HISTORIC AND DESIGN REVIEW COMMISSION February 07, 2018

HDRC CASE NO: ADDRESS: LEGAL DESCRIPTION: ZONING: CITY COUNCIL DIST.: DISTRICT: APPLICANT: OWNER: TYPE OF WORK: APPLICATION RECEIVED:	 2017-588 814 BURNET ST NCB 549 (814 BURNET SUB'D {IDZ}), BLOCK 9 LOT 18 IDZ H 2 Dignowity Hill Historic District Felix Ziga/Ziga Architecture Studio Poma Properties, LLC Construction of four, two story, single family residential structures January 19, 2018
APPLICATION RECEIVED:	January 19, 2018
60-DAY REVIEW:	March 20, 2018

The applicant is requesting a Certificate of Appropriateness for approval to construct four, two story residential structures on the vacant lot at 814 Burnet.

NEW SINGLE FAMILY RESIDENCE 814 BURNET ST. - LOT 20, SAN ANTONIO, TX 78202

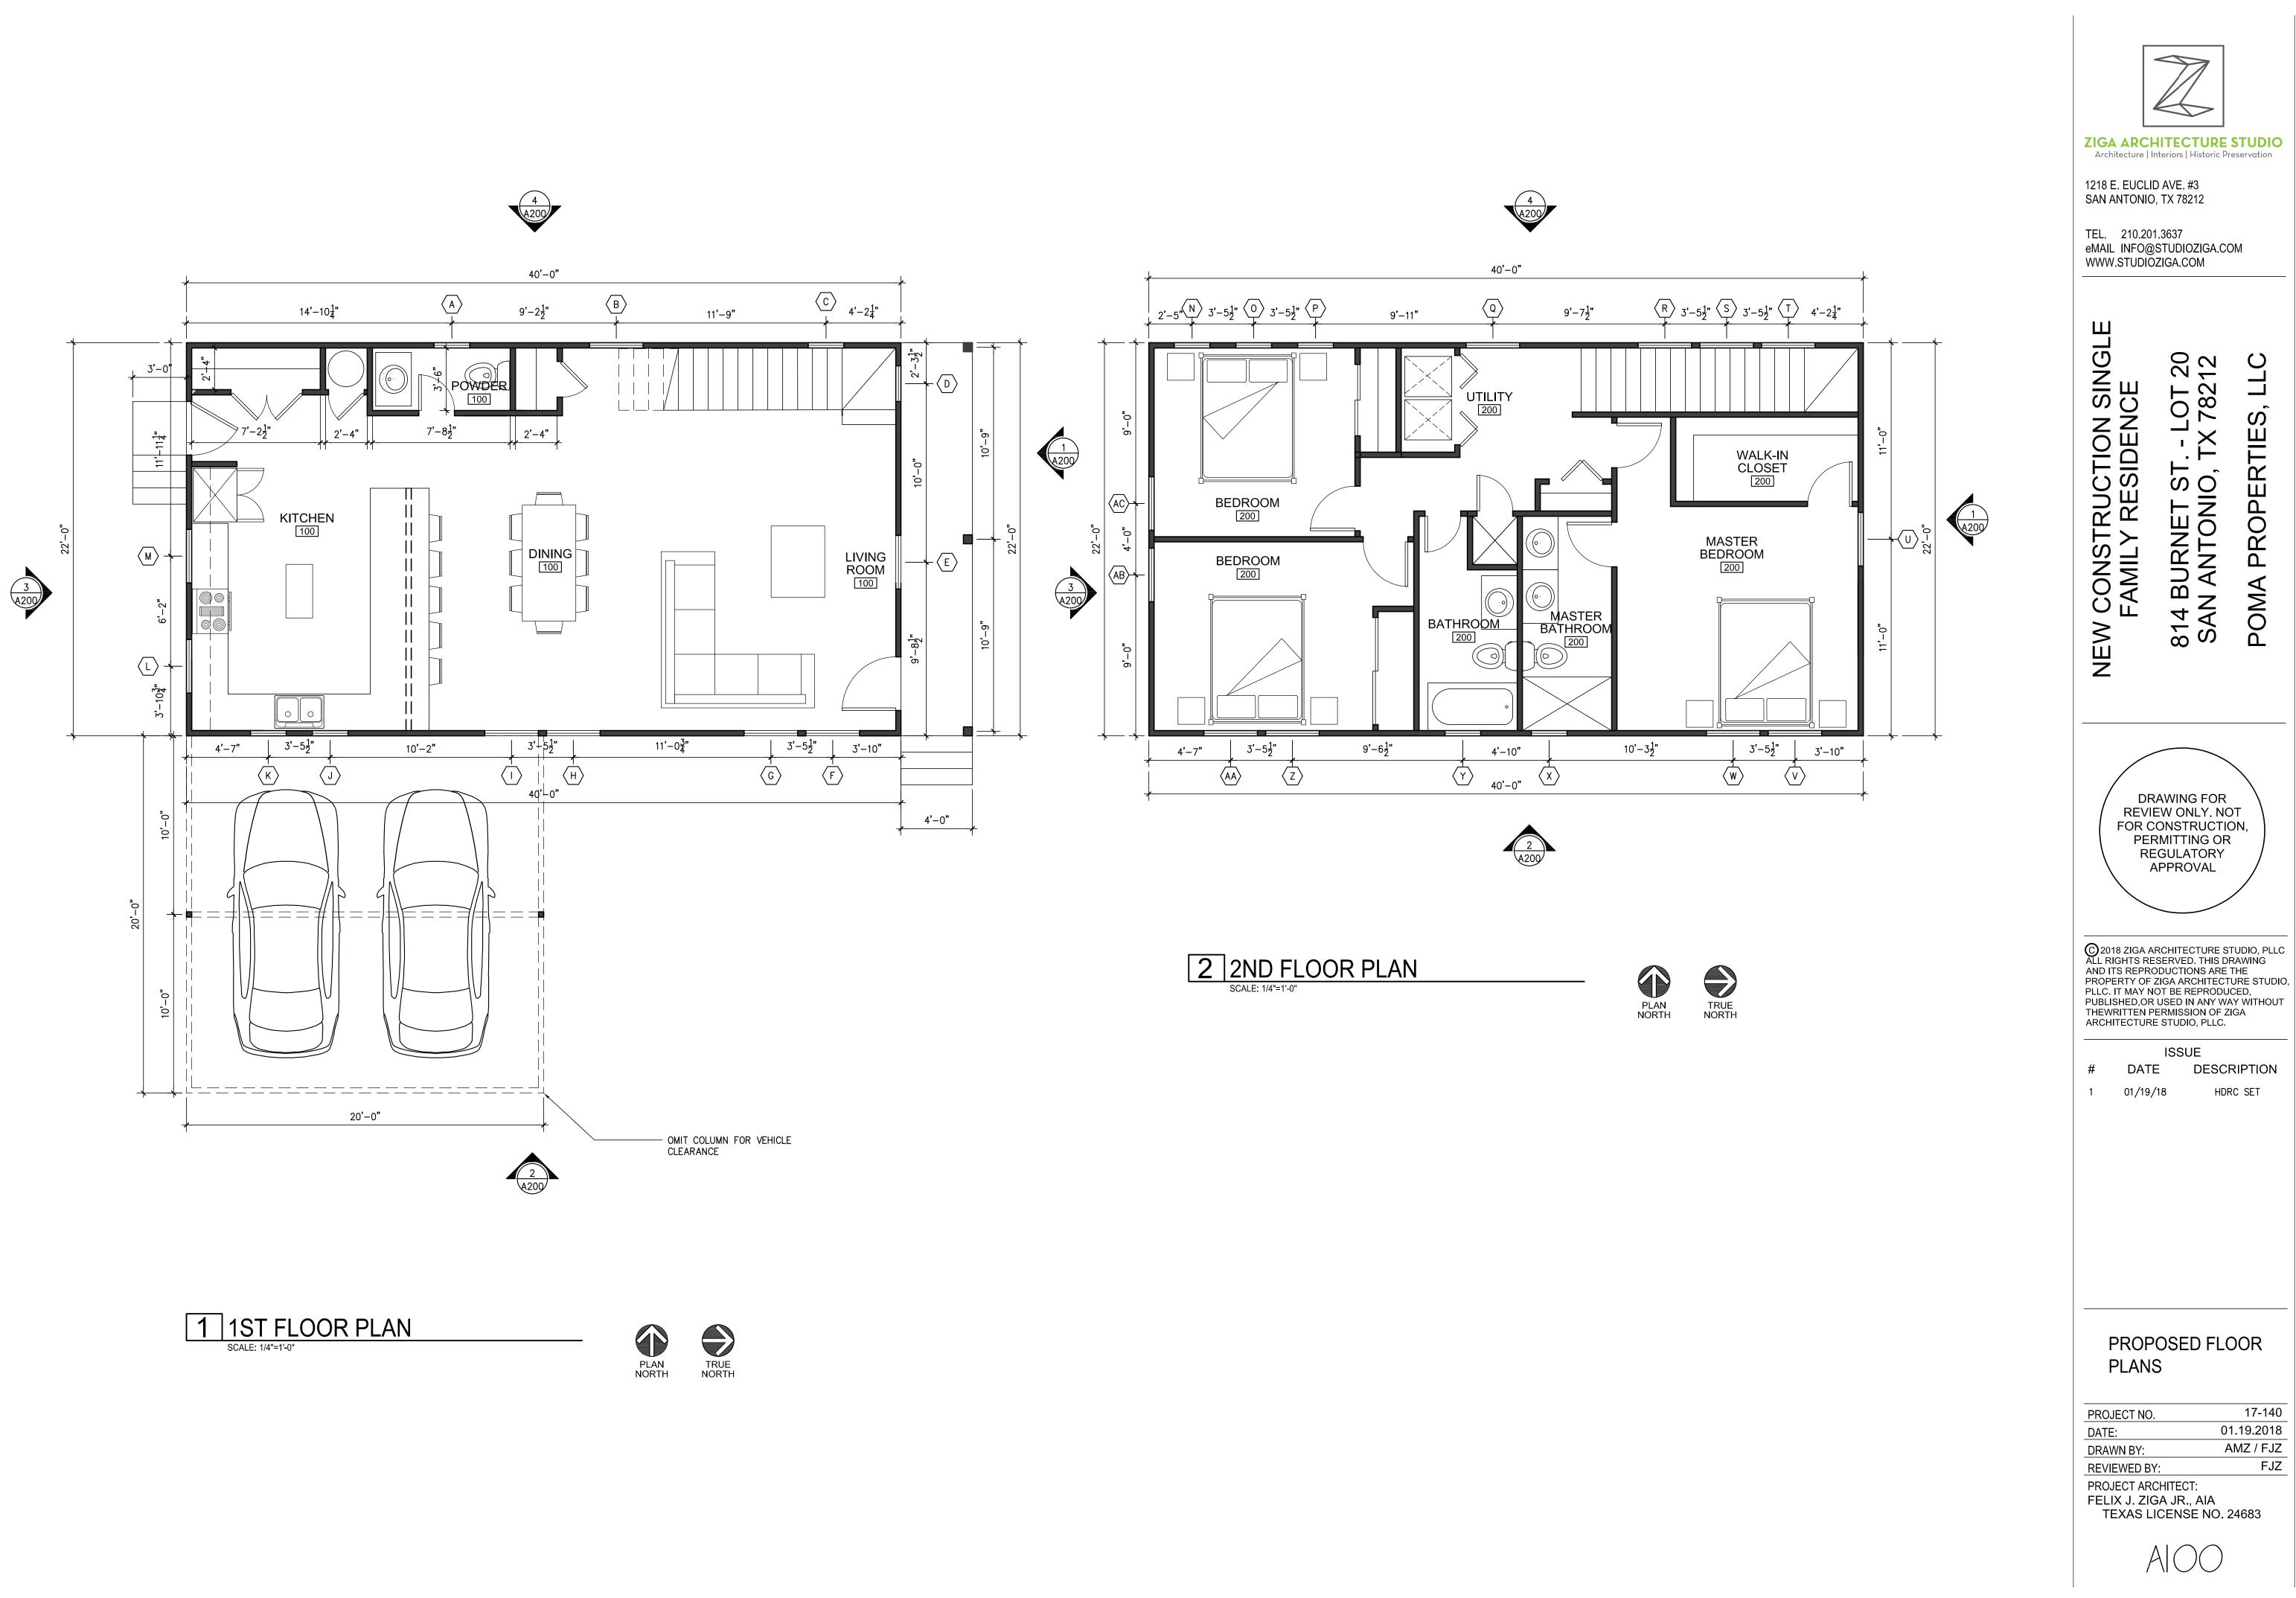
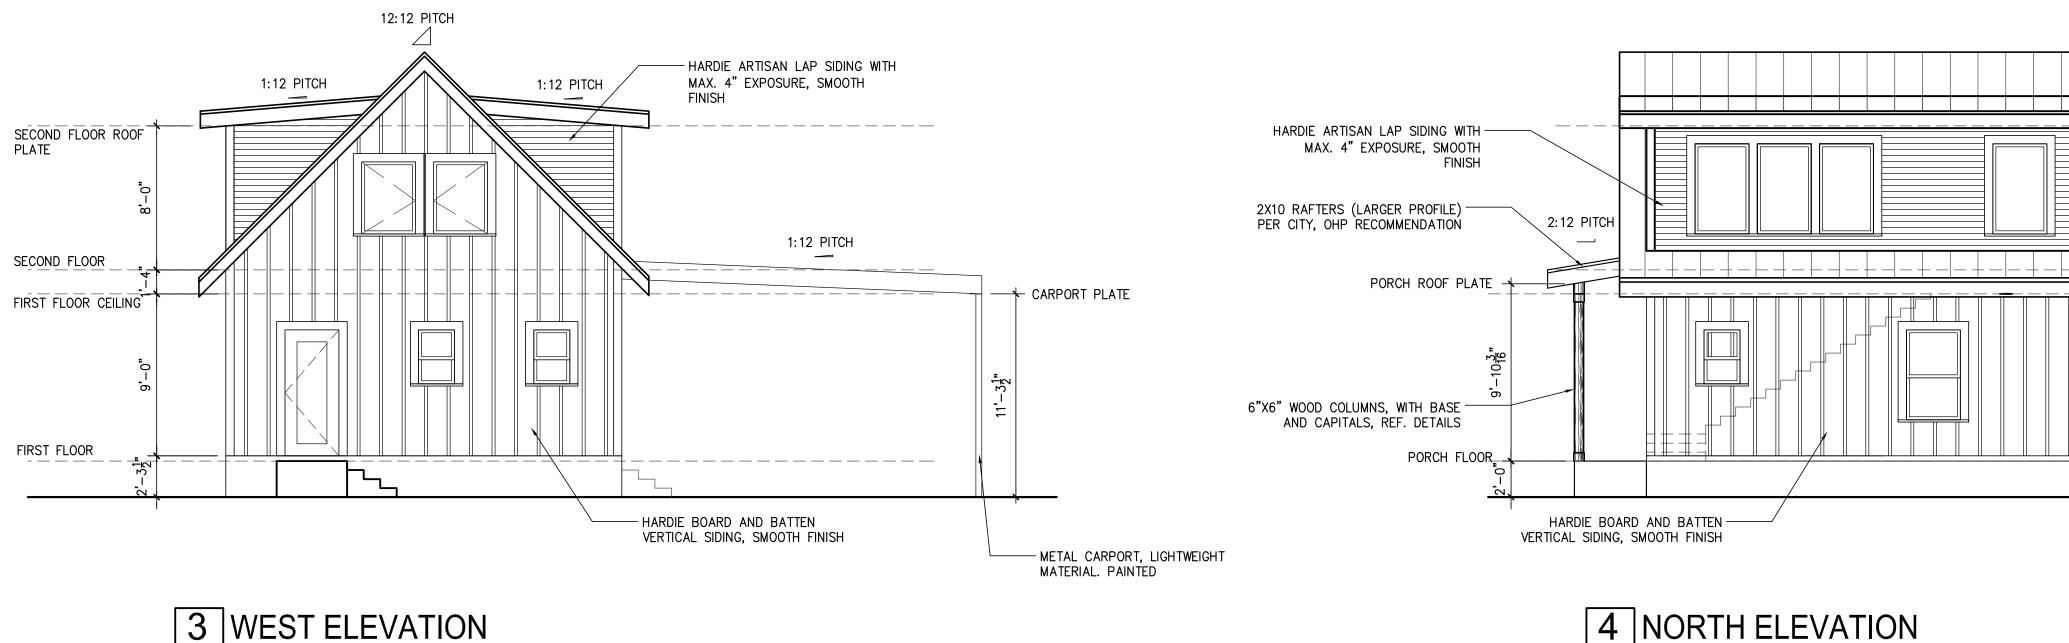
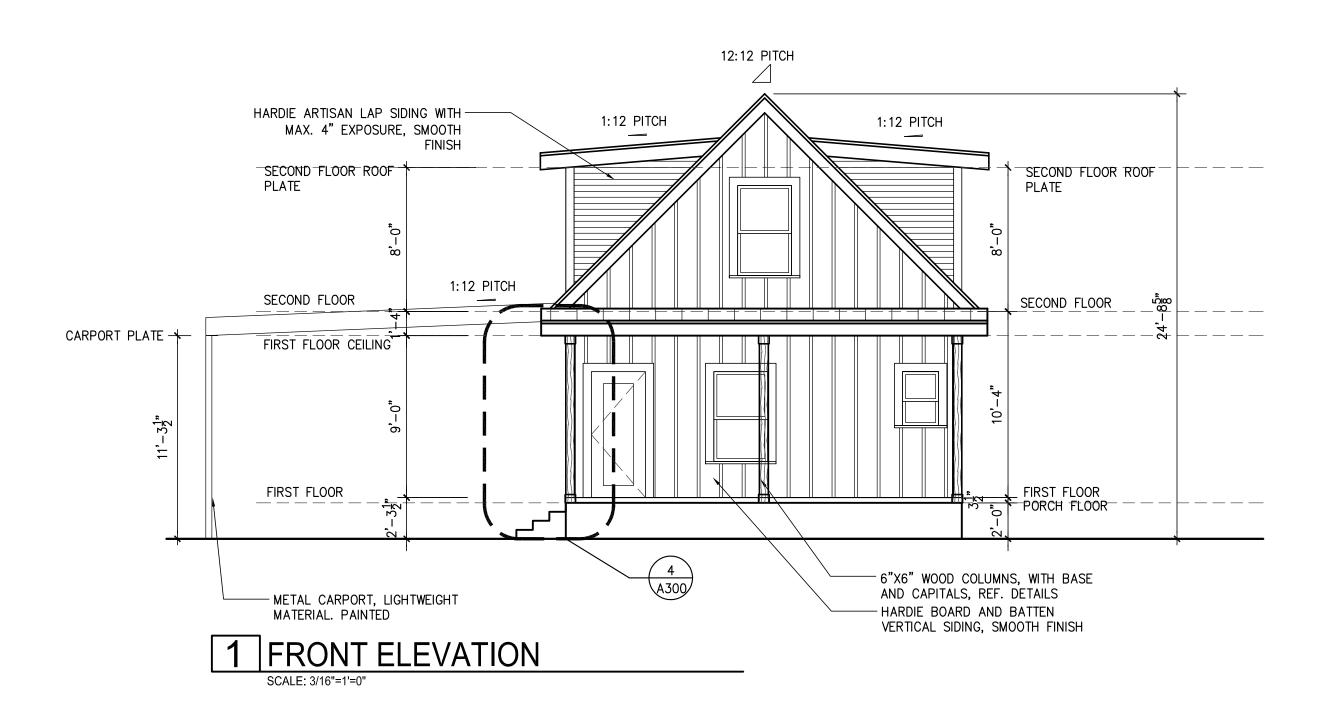
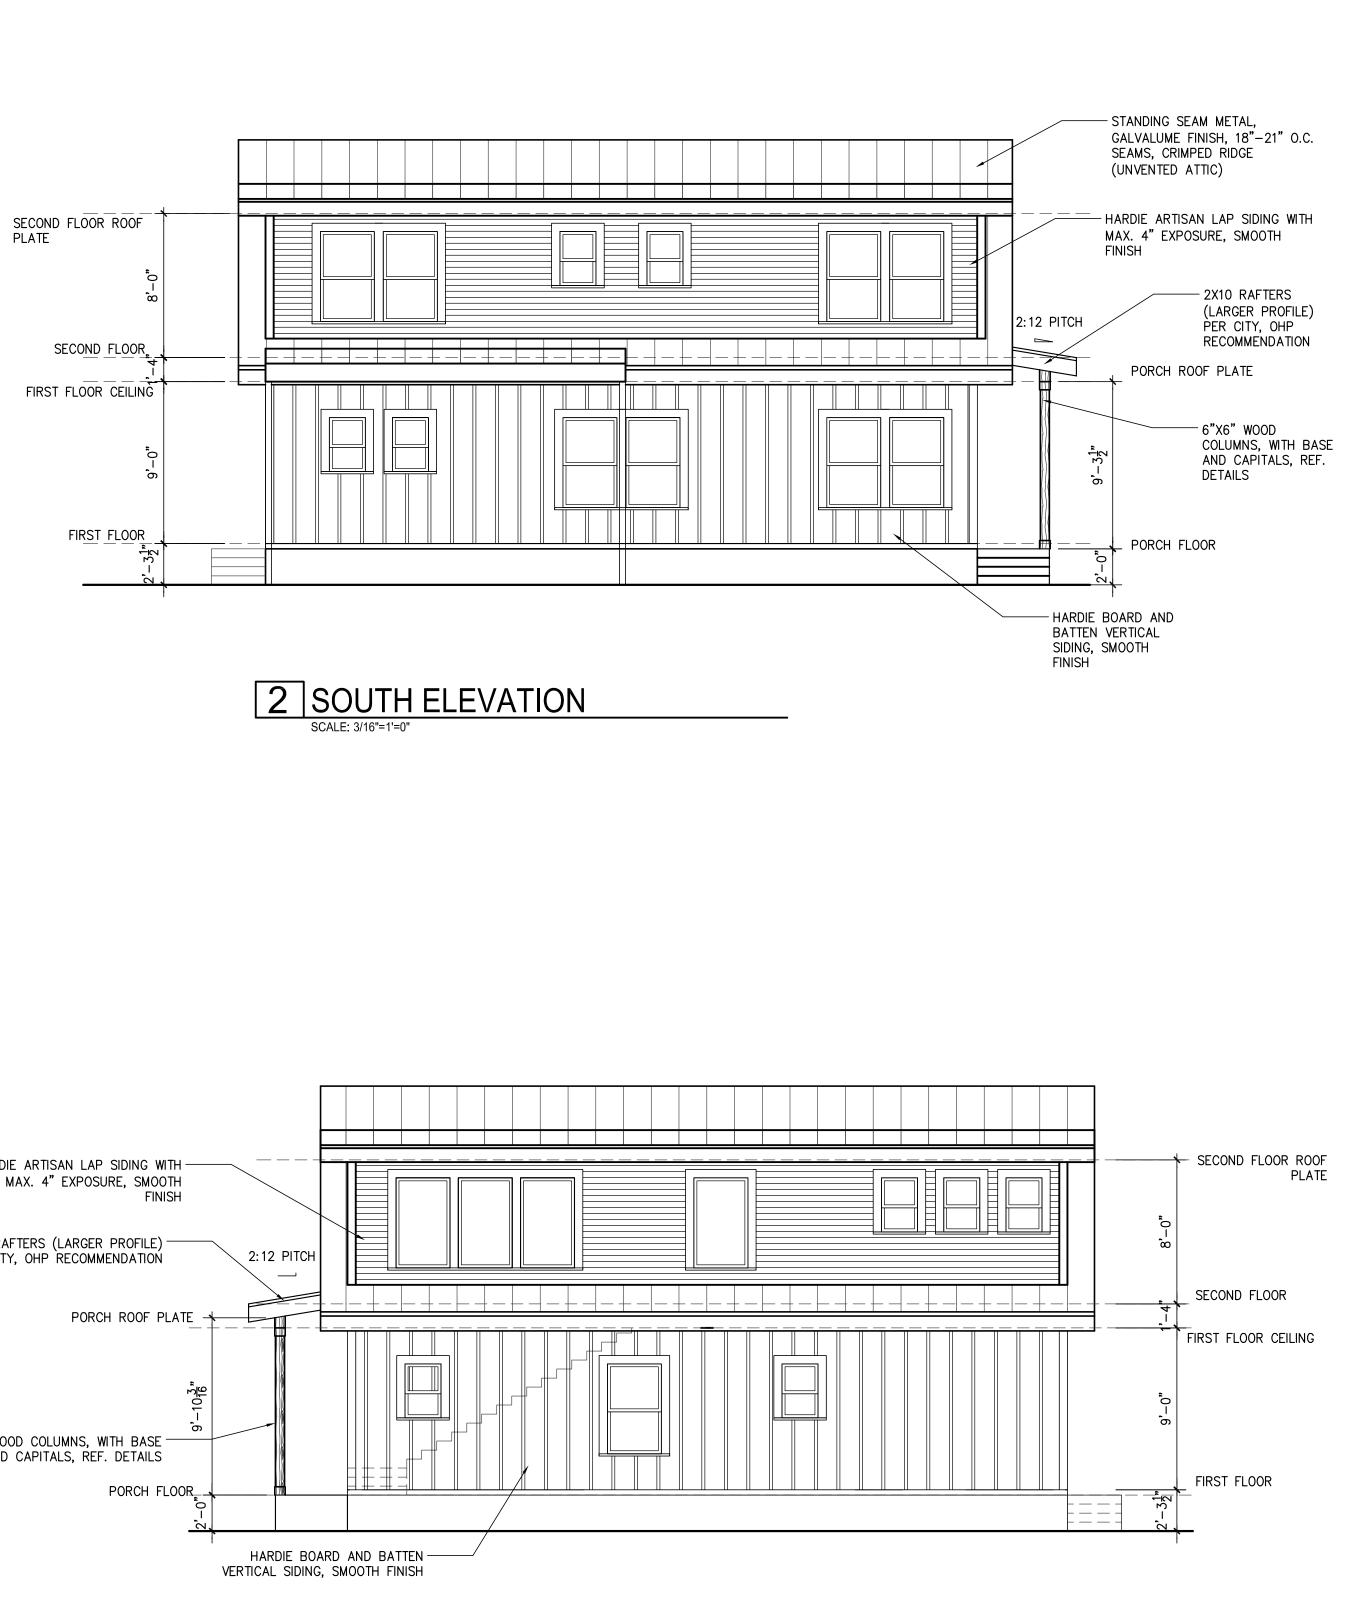
- o. ARCHITECTURAL DETAILS (FENESTRATION) The structure proposed on lot 21 features a structure where most of the street facing façade lacks ground level fenestration. Staff finds that the front door should be shifted from the corner and additional fenestration added in the form of full size windows.

- i. That the proposed wood windows for all proposed structures follow the window installation specifications outlined in finding k.
- ii. That the structure proposed on lot 21 features additional ground level fenestration and a front door that is removed from the building corner. Windows on all structures, including those located on the dormers, must comply with stipulations regarding window size, proportion, and detail.

4 COLUMN DETAIL SCALE: 3/4"=1'-0"

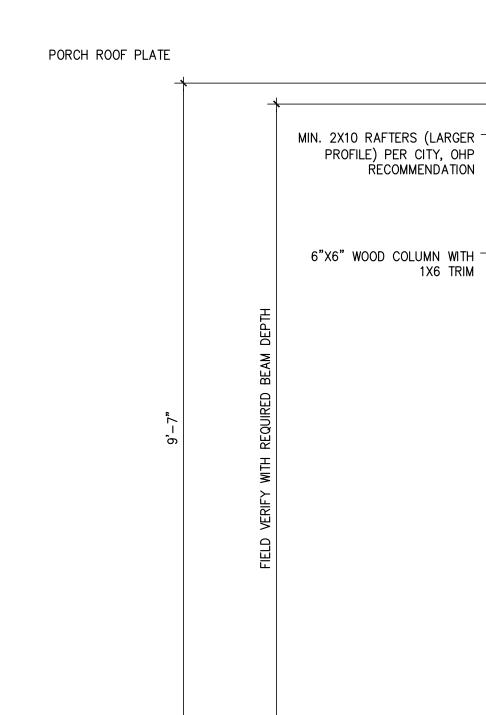
- p. COLUMN DESIGN The applicant has proposed cedar front porch columns; however, at this time has not included a column detail determining trim and dimensions. Staff finds that a column not to exceed six (6) inches in width should be used.
